**DEVELOPMENT REVIEW COMMISSION  
STAFF REPORT**

CASE NO.: 21-32000001 PLAT SHEET: F-7

REQUEST Approval of a Special Exception and related Site Plan to construct an accessory surface parking lot on a residentially zoned lot to construct a 45,000 square-foot office in the CCT-1 and NSM-1 zoning district.

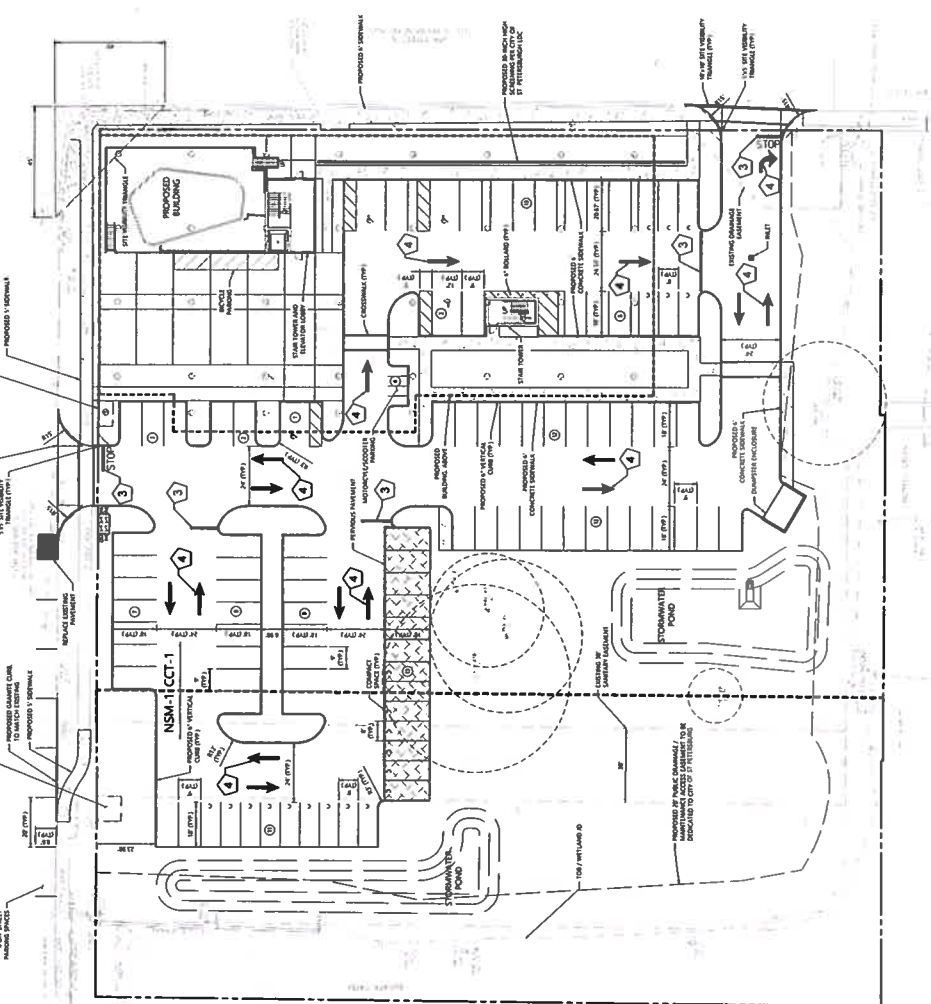
6. It appears that the proposed driveway onto 4<sup>th</sup> Street South is too close to the bridge structure to allow for a proper curb and sidewalk transition to be constructed. Construction plans shall show the adjustment of this driveway location as necessary to allow the public sidewalk and curb to be constructed to meet City standards without the driveway encroaching onto the bridge approach. Detailed plan review will occur with plan submittal for construction permits.

The northeastern corner of the proposed building is located slightly inside the site triangle of the intersection of 4<sup>th</sup> Street and 11<sup>th</sup> Avenue South as shown on the site plan. To meet the requirements of Section 16.40.160, the building location or design will need to be adjusted.

The sidewalk along 4<sup>th</sup> Street is adjacent to the curb. We recommend that it be moved as far away from the curb as possible to provide increased safety for pedestrians. The driveway on 4<sup>th</sup> Street is located very close to the bridge over Booker Creek. The driveway may need to be moved slightly north to ensure that the southern driveway radius and sidewalk facility can be constructed according to the City's engineering design standards.

The existing bus stop on 4<sup>th</sup> Street is identified on the site plan but no improvements are indicated. The existing stop consists of a bench, small bench pad, trash receptacle and sign. The applicant needs to identify the location of the bench and sign. We recommend that the applicant contact Mike Hetrick at the Pinellas Suncoast Transit Authority (PSTA) at [MHetrick@psta.net](mailto:MHetrick@psta.net) to discuss what is needed to ensure that the transit stop complies with federal and state requirements for accessibility. We anticipate that a 5-foot by 8-foot boarding and alighting area will be needed. The applicant is utilizing the provision in the Code to reduce off-street parking by 10% because of its proximity to a high-frequency transit route (Route 4). Route 4 is one of PSTA's most popular routes and most frequent routes, with a 15-minute headway between buses. PSTA may be interested in improving the facilities at this stop, such as installing a shelter, to better serve existing riders and potential riders from the new office development.

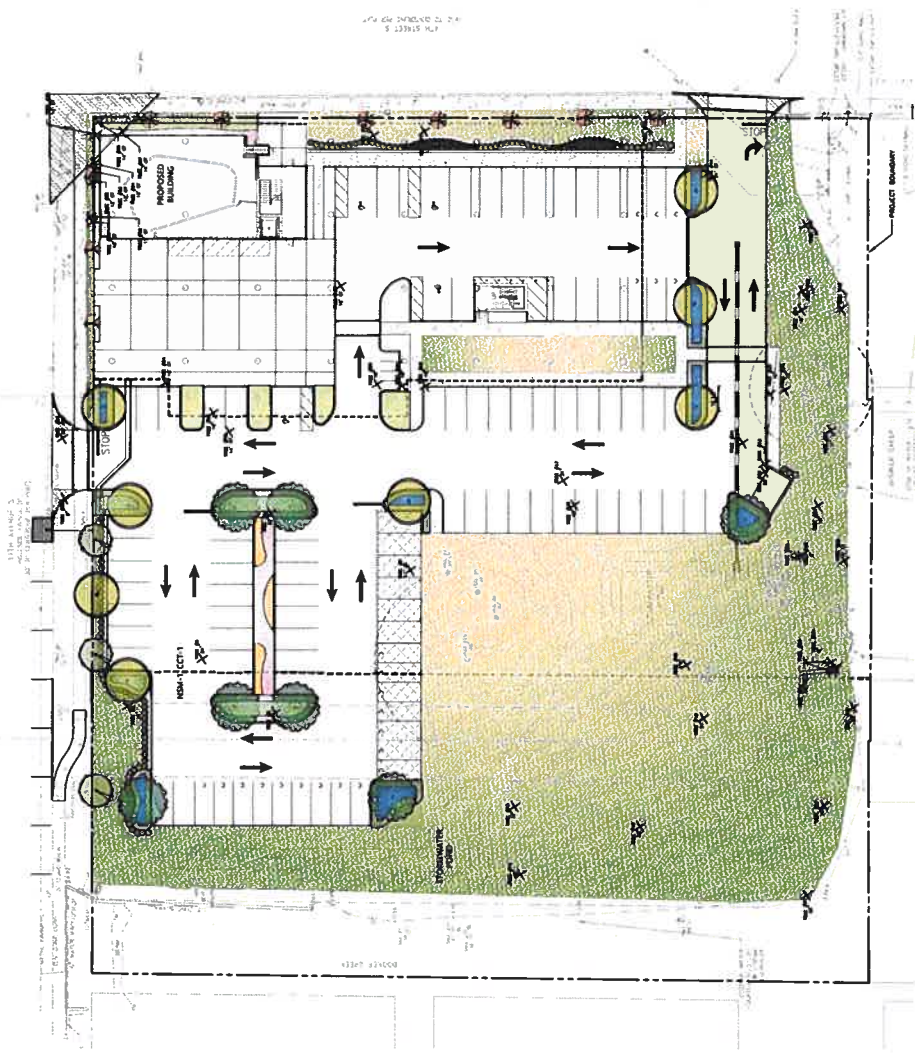
7. The 30-inch (DBH) Southern Red Cedar tree (referred to as No. 51 on the landscape plan) shall be preserved unless the City's Arborist permits the removal.

1. The landscape plan submitted proposes the removal of a number of healthy trees along the creek bank without any replacement trees. I was told the city was requiring removal of these trees because they're invasive. However, I spoke with Shane Largent about this and he said while the mahoe ("sea hibiscus") trees are technically on a list of invasive species, they're not actually invasive in this environment and the city would not require their removal. I understand they are not regulated and the applicant has the right to remove them. However, I would like to see them left unless they're going to plant something equal or better.

2. The landscape plan submitted does a nice job of screening the parking lot with vegetation along 11th Avenue South. I would like to see the same vegetative buffer along the west and south sides of the parking lot, drive aisles, and around the dumpster enclosure. I'm not too familiar with this section of the code but hopefully it requires buffers between parking lots and adjacent residential uses.
